SUBJECT: ISSUANCE OF AMENDMENT NOS. 188, 188 AND 185 TO FACILITY OPERATING  
LICENSES DPR-38, DPR-47 AND DPR-55 - OCONEE NUCLEAR STATION,  
UNITS 1, 2 AND 3 (TACS 75344, 75345, 75346)

The amendments revise the Pressure/Temperature Limits and the Low Temperature  
Overpressure Protection system operability requirements in Section 3.1 of the  
TSs and revise the associated bases.

SAFETY-EVALUATION-BY-THE-OFFICE-OF-NUCLEAR-REACTOR-REGULATION  
RELATED-TO-AMENDMENT-NO.-188-TO-FACILITY-OPERATING-LICENSE-DPR-38

OCONEE-NUCLEAR-STATION,-UNITS-1,-2,-AND-3

Figure 3.1.2-1A

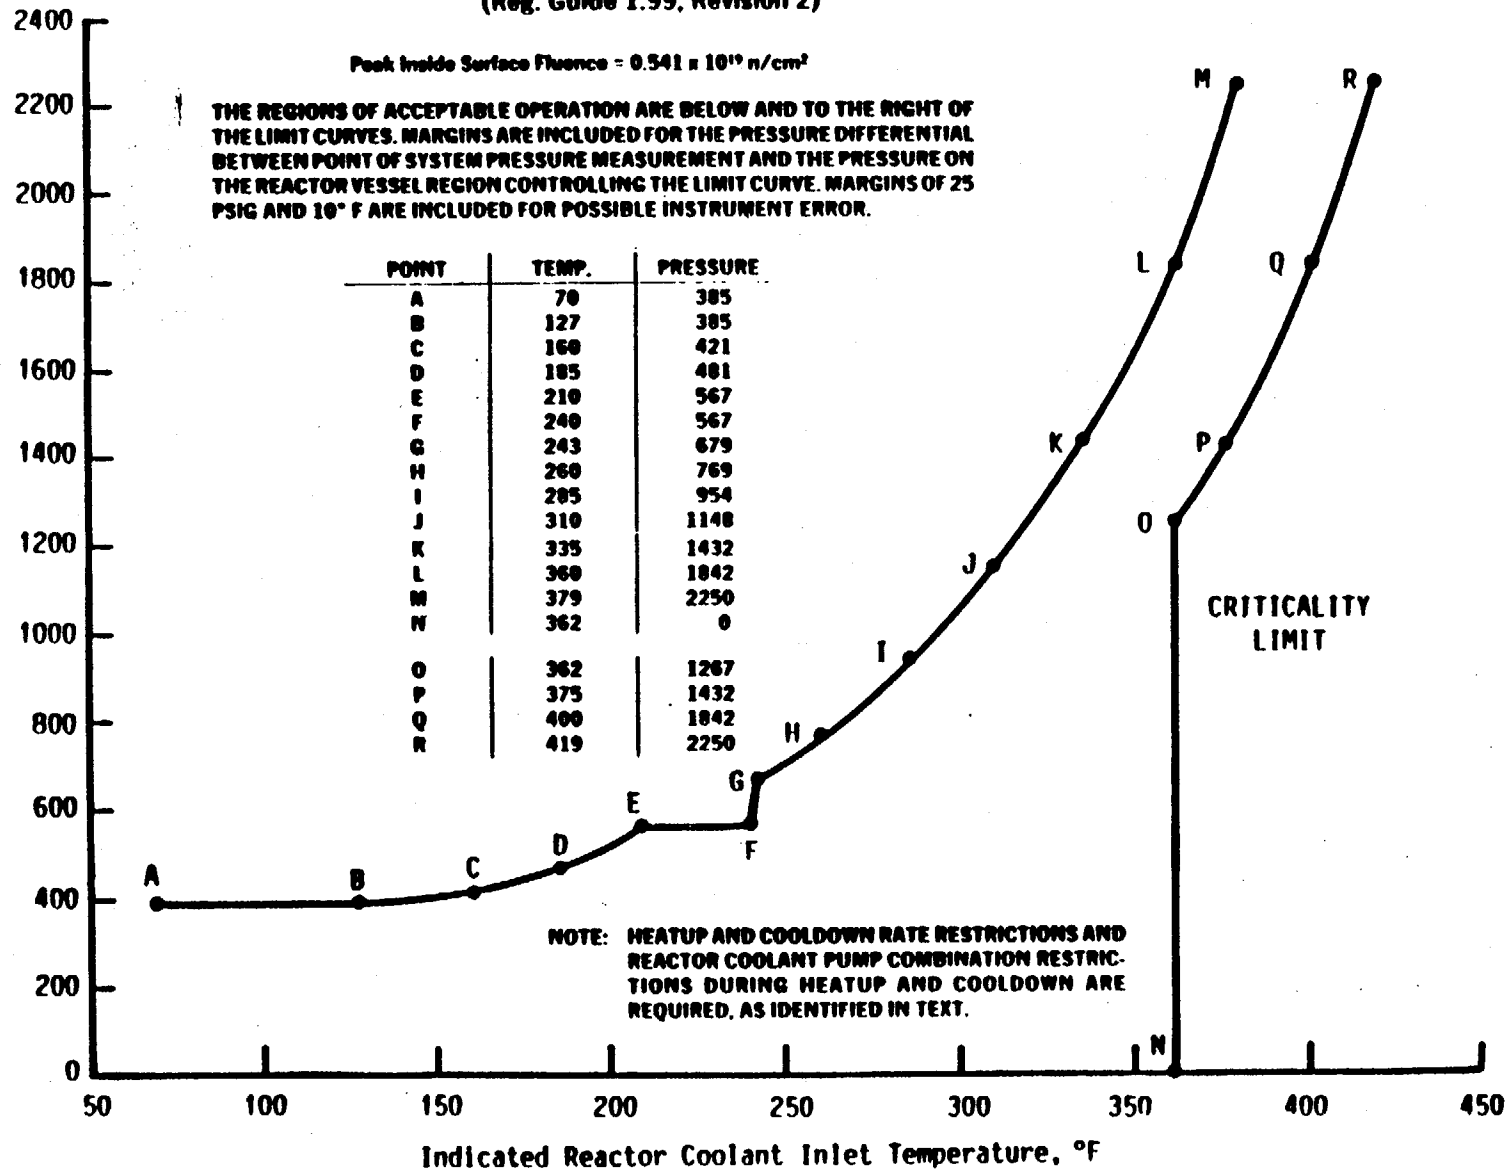
Unit 1 Oconee Nuclear Station  
Reactor Coolant System Normal Operation Heatup  
Limitations Applicable for First 15.0 EFPY  
(Reg. Guide 1.99, Revision 2)

The changes to P/T limits are in response to Generic Letter (GL) 88-11, "NRC Position on Radiation Embrittlement of Reactor Vessel Materials and Its Effect On Plant Operation." The current P/T limit curves are based on an assumed design basis neutron fluence through 15 effective full power years (EFPYs). The proposed P/T limit curves were developed based on the guidance of Regulatory Guide (RG) 1.99, Rev. 2, "NRC Position on Radiation Embrittlement of Reactor Vessel Materials and Its Impact on Plant Operations," and they are applicable for a period of up to 15 EFPYs. Prompted by the P/T Limit revisions, changes to the low temperature overpressure protection (LTOP) system requirements (TS 3.1.9.2) have been proposed to assure proper protection to the reactor vessel.

The licensee calculated the ARTs of  $184^{\circ}\text{F}$  and  $140^{\circ}\text{F}$  at  $1/4T$  and  $3/4T$ , respectively. Substituting the ARTs of  $184^{\circ}\text{F}$  and  $140^{\circ}\text{F}$  into equations in SRP 5.3.2, the staff verified that the proposed P/T limits for heatup, cooldown, and hydrotest meet the beltline material requirements in Appendix G of 10 CFR Part 50.

Figure 3.1.2-1B

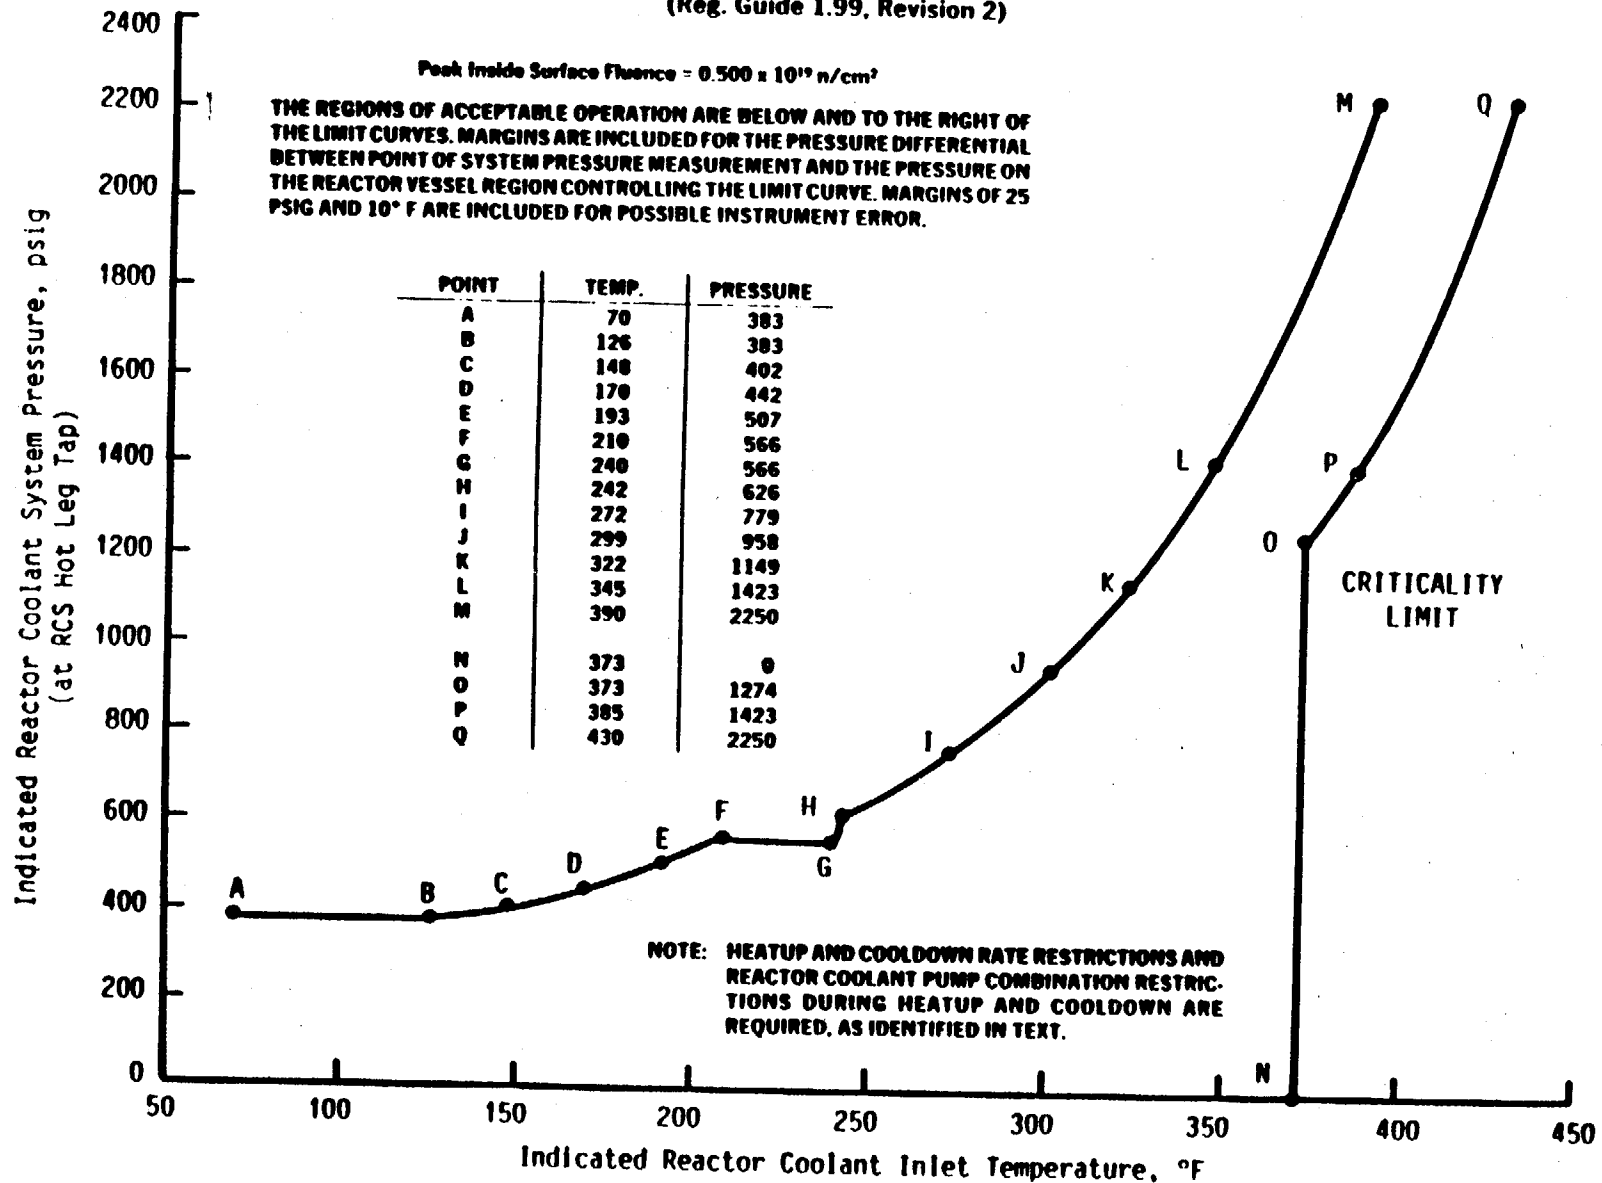
Unit 2 Oconee Nuclear Station  
Reactor Coolant System Normal Operation  
Heatup Limitations Applicable for First 15.0 EFY  
(Reg. Guide 1.99, Revision 2)

The licensee selected the weld, WF-25, as the limiting material and calculated the ARTs of 193°F and 139°F at 1/4T and 3/4T, respectively. The licensee's ARTs are conservative; therefore, they are acceptable. Substituting the ARTs of 193°F and 139°F into equations in SRP 5.3.2, the staff verified that the proposed P/T limits for heatup, cooldown, and hydrotest meet the beltline material requirements in Appendix G of 10 CFR Part 50.

Figure 3.1.2-1C

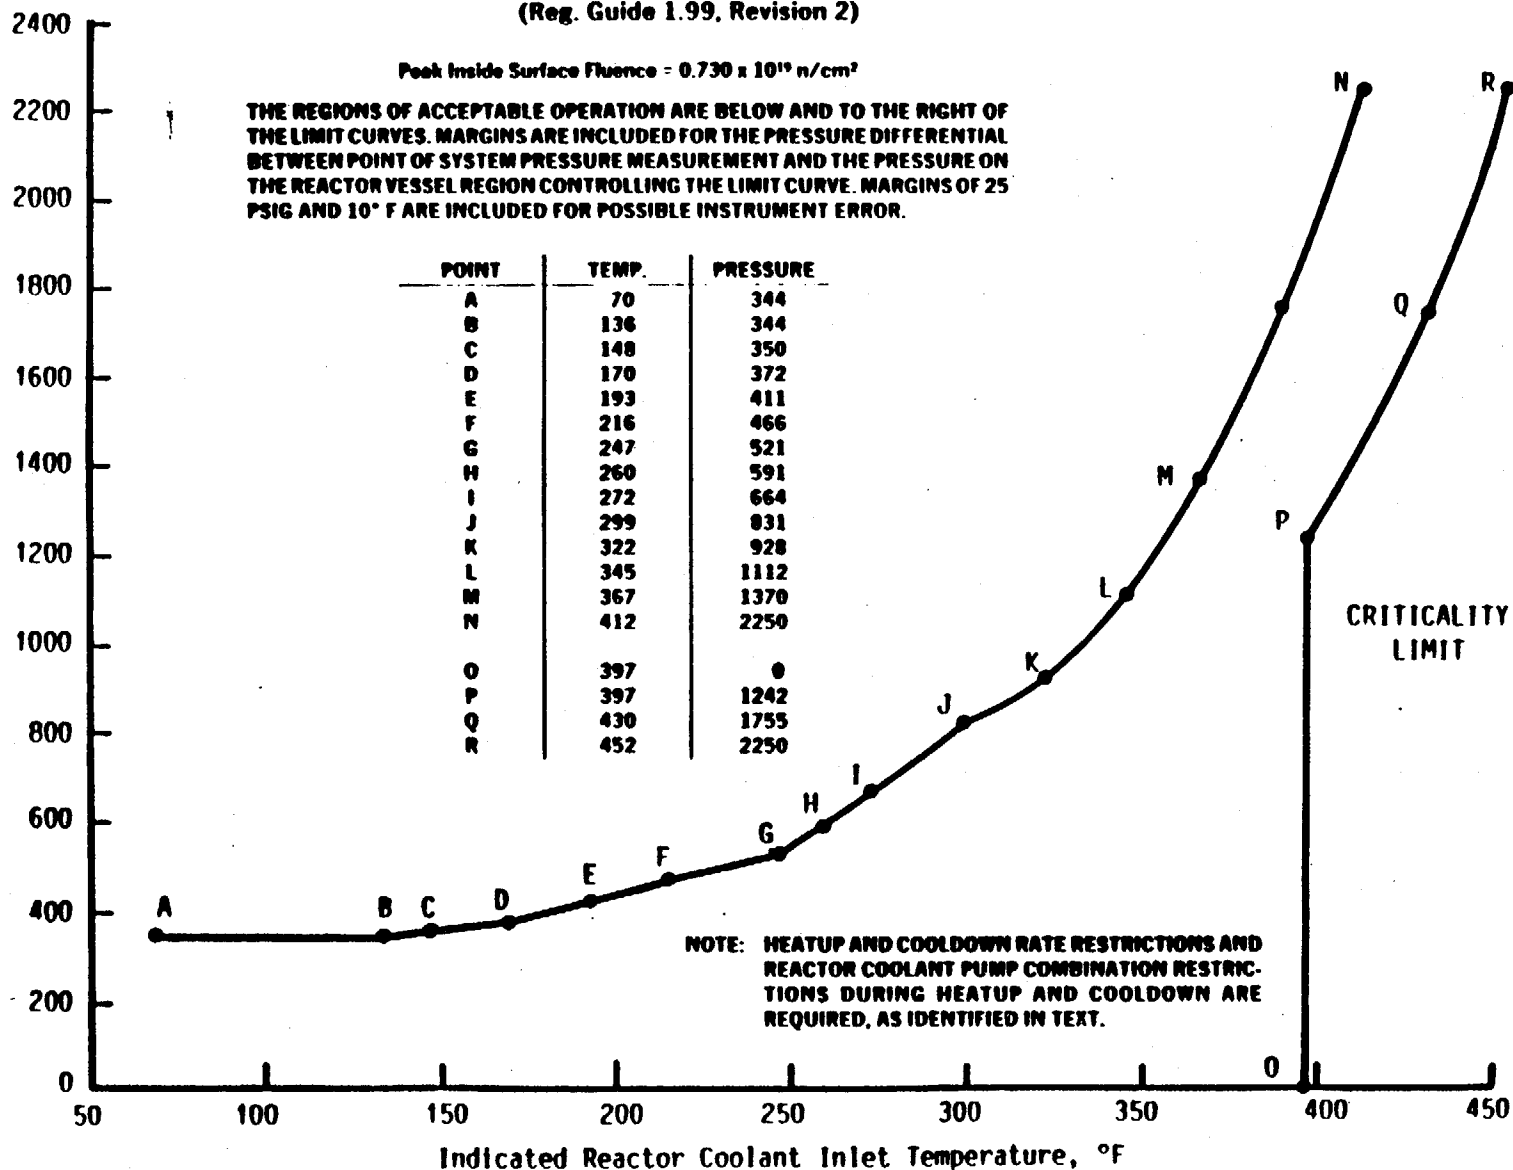
**Unit 3 Oconee Nuclear Station  
Reactor Coolant System Normal Operation Heatup  
Limitations Applicable for First 15.0 EFPY  
(Reg. Guide 1.99, Revision 2)**

The licensee selected welds WF-67 and WF-70 as the limiting materials at the 1/4T and 3/4T locations, respectively, and calculated the ARTs of 195°F at 1/4T and 171°F at 3/4T. The difference between the staff's ART and the licensee's ART at the 1/4T location (202°F vs. 195°F) is because the licensee used a lower chemistry factor in the ART calculation. Substituting the ARTs of 202.2°F and 171°F into equations in SRP 5.3.2, the staff verified that the proposed P/T limits for heatup, cooldown, and hydrotest meet the beltline material requirements in Appendix G of 10 CFR Part 50. The licensee's P/T limits have sufficient safety margin such that with a lower ART the limits satisfy the Appendix G calculation.

Figure 3.1.2-2A

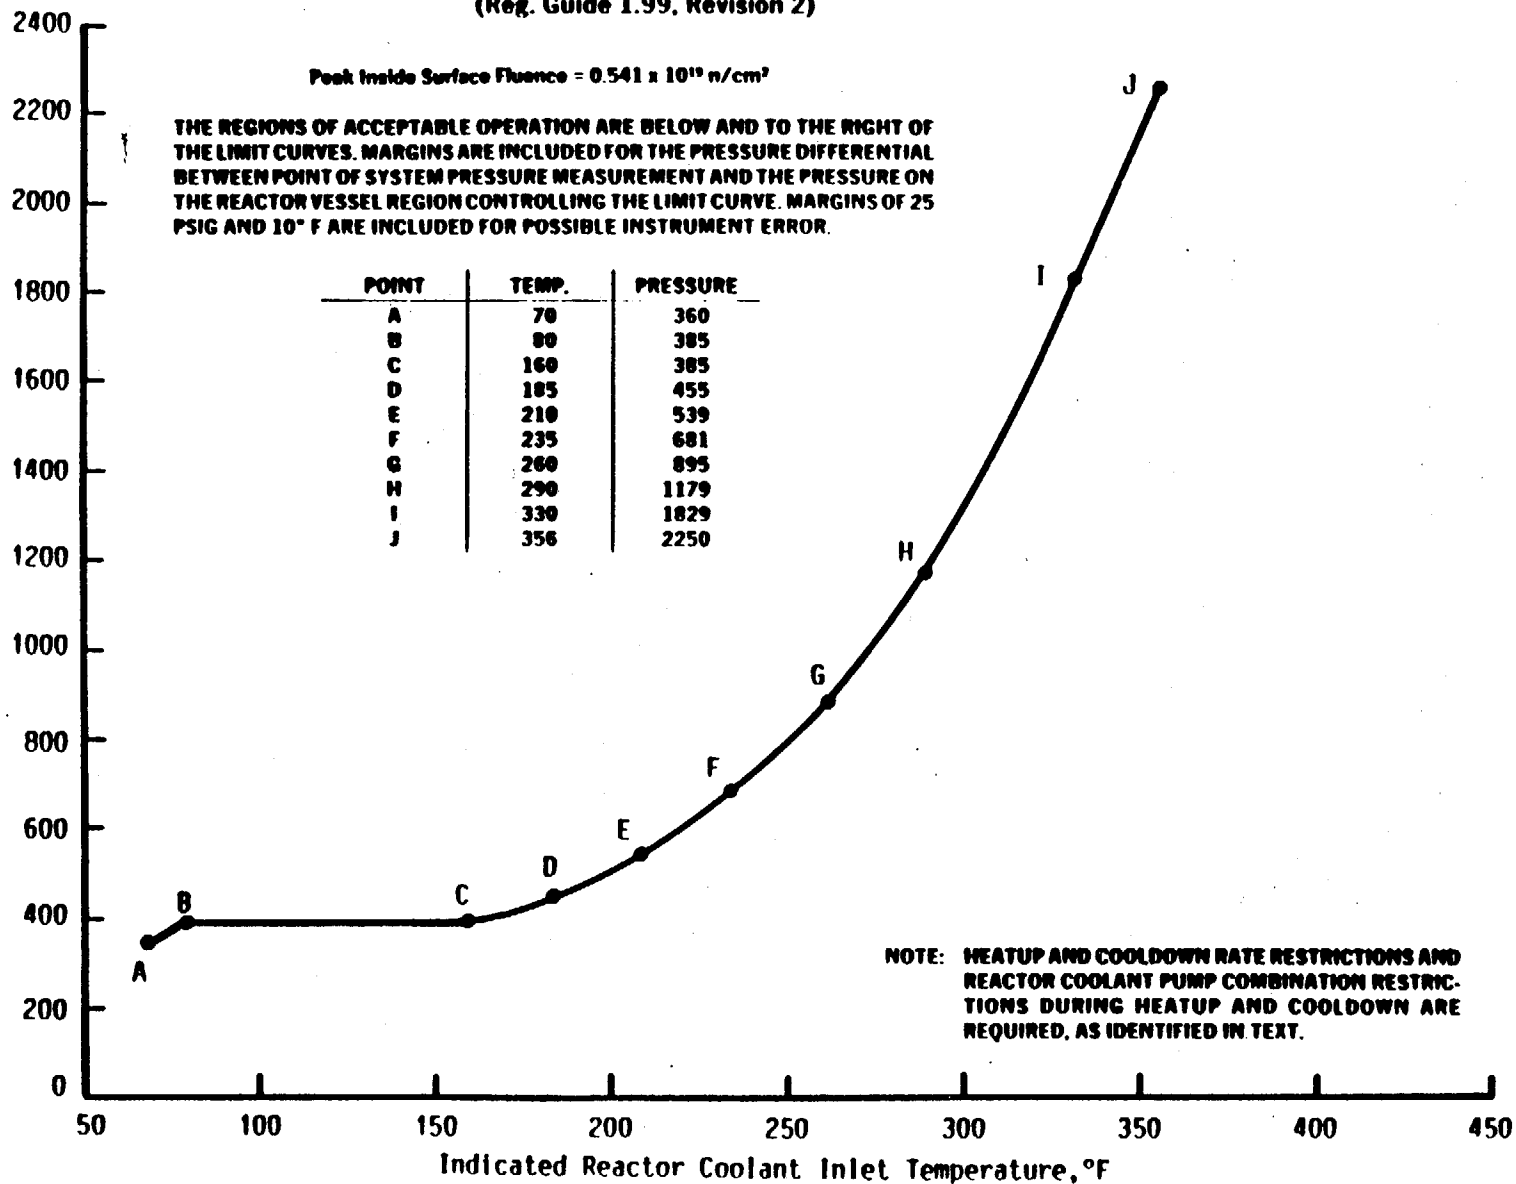
Unit 1 Oconee Nuclear Station  
Reactor Coolant System Normal Operation  
Cooldown Limitations Applicable for First 15 EFPY  
(Reg. Guide 1.99, Revision 2)

Figure 3.1.2-2B

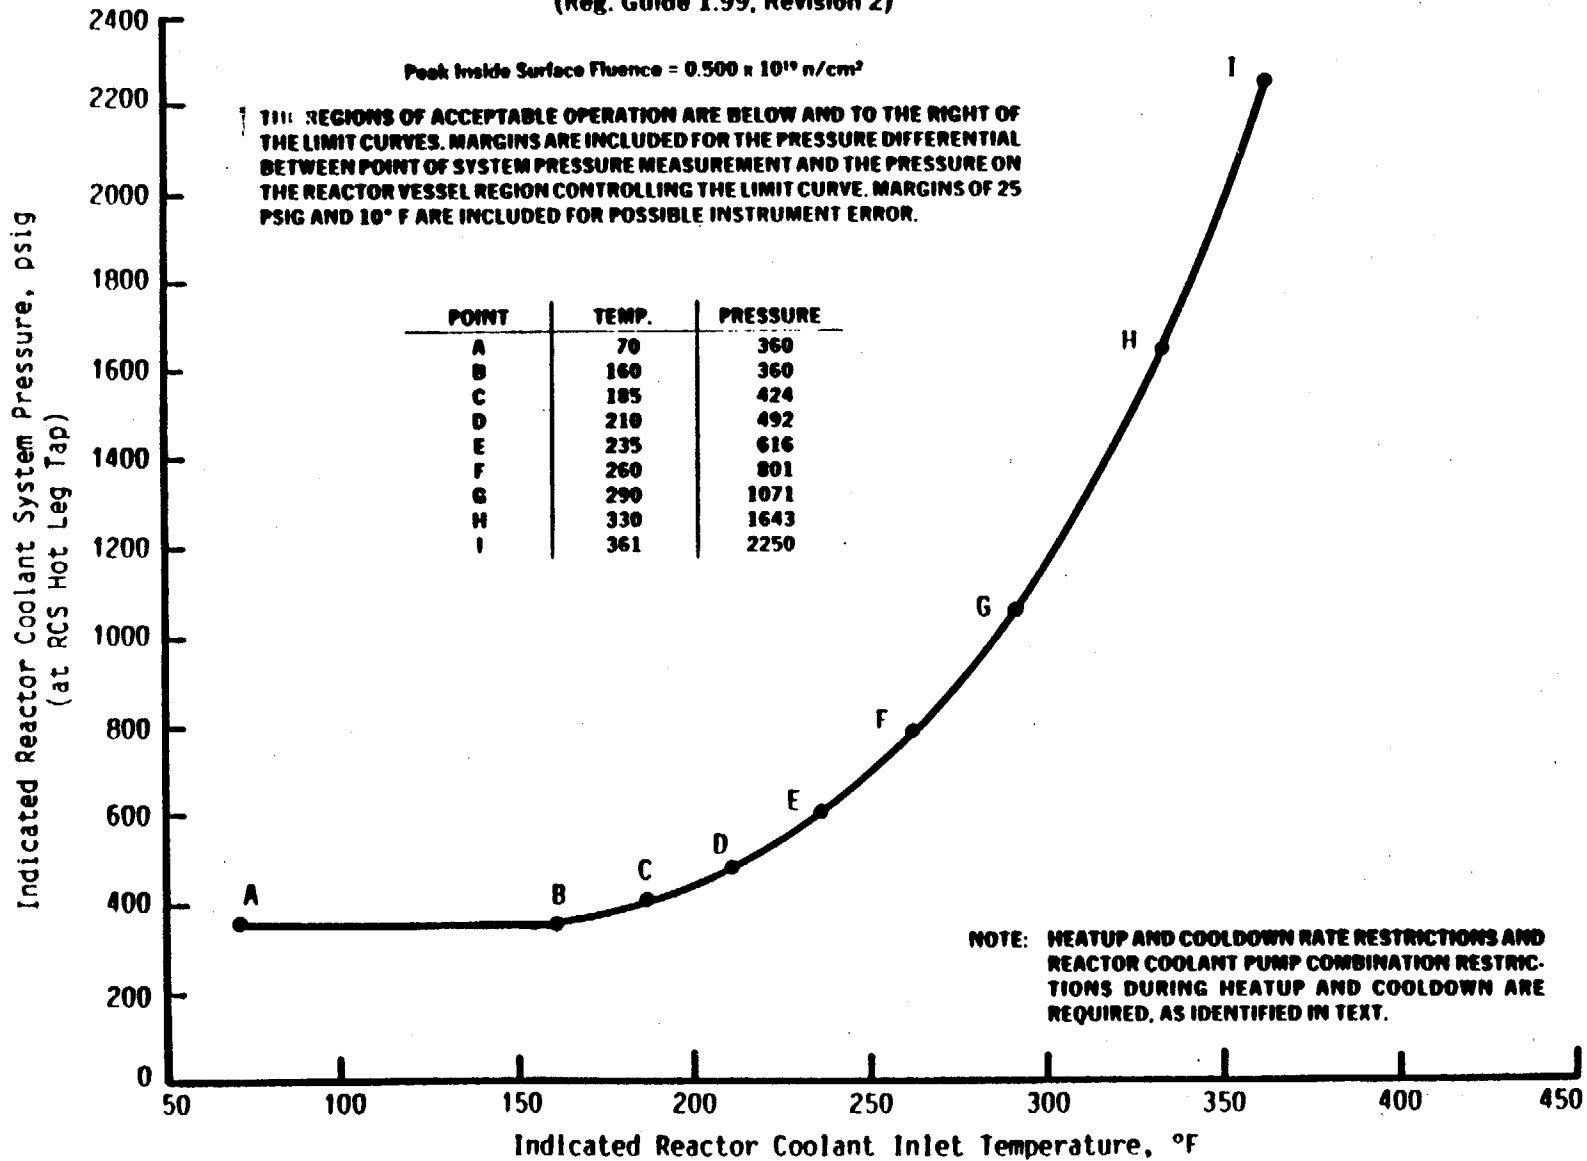
**Unit 2 Oconee Nuclear Station  
Reactor Coolant System Normal Operation Cooldown  
Limitations Applicable for First 15.0 EFPY  
(Reg. Guide 1.99, Revision 2)**
